# Intel® I/O Controller Hub 9 (ICH9) Family

## Specification Update

— *For the Intel® 82801IB ICH9, 82801IR ICH9R, and 82801IH ICH9DH, 82801IO ICH9DO I/O Controller Hubs*

**June 2008**

### 3. External RTC Circuit Correction

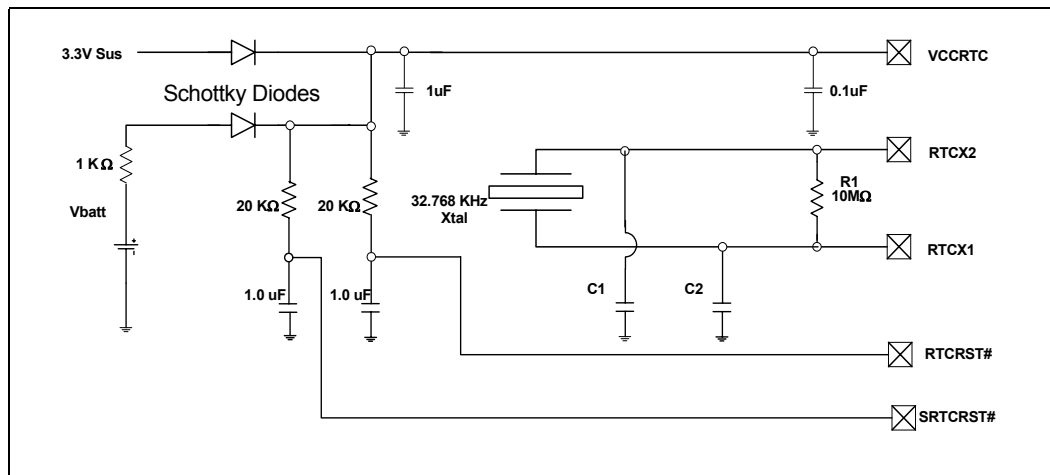
The following figure replaces Figure 2-2 of the Datasheet.
